Access Compliance Report

Public Rights-of-Way

(Curb Ramps)

Intersection ID: N/A	Main Street: YORK_CENTER	Cross Street: N/A	Location: E
ADA ID: 88D647E8D803	Ramp Type: PerpDiag	Initial Pass/Fail: Fail	Overall Compliance: No
Severity Score: 21.25			
Codes/Mitigation Info/Possible Solution		Field Measurements/Component Compliance

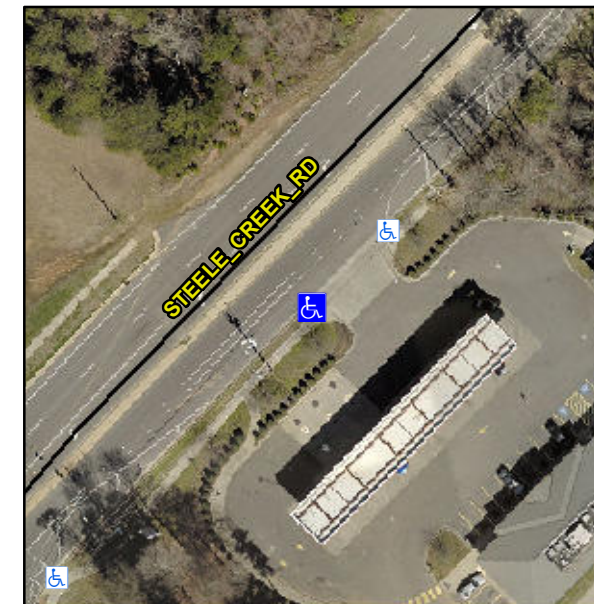
R304.5.1, R304.5.3

Compliance	Description	Data	Compliance	Description	Data
N/A	Ramp Length (in)	59.0	Yes	Ramp Slope (%)	5.3
No	Ramp Width (in)	44.0	No	Ramp XSlope (%)	5.4
N/A	Flare Type LT	N/A	N/A	Flare Type RT	N/A
N/A	Flare Slope LT (%)	N/A	N/A	Flare Slope RT (%)	N/A
N/A	Flare Traversable LT?	N/A	N/A	Flare Traversable RT?	N/A
N/A	Landing Length (in)	N/A	N/A	DWS Provided?	N/A
N/A	Landing Width (in)	N/A	N/A	DWS Contrast?	N/A
N/A	Landing Slope (%)	N/A	N/A	DWS Length (in)	N/A
N/A	Landing X Slope (%)	N/A	N/A	DWS Full Width?	N/A
N/A	Landing Curb? (Y/N)	N/A	N/A	DWS Offset (in)	N/A
N/A	Shared Landing?	N/A			
N/A	Gutter Ponding?	N/A	N/A	Gutter Slope (%)	N/A
N/A	Gutter Lip Ht (in)	N/A	N/A	Gutter X Slope (%)	N/A
N/A	Painted X Walk1?	No	N/A	Painted X Walk2?	No
	X Walk 1 Direction	To N		X Walk 2 Direction	To W
N/A	X Walk 1 Width (in)	N/A	N/A	X Walk 2 Width (in)	N/A
	X Walk 1 Slope (%)	2.4		X Walk 2 Slope (%)	10.2
	X Walk 1 X Slope (%)	6.7		X Walk 2 X Slope (%)	2.0

Remove & Replace Curb Ramp With Two New Directional Ramps or Equivalent.
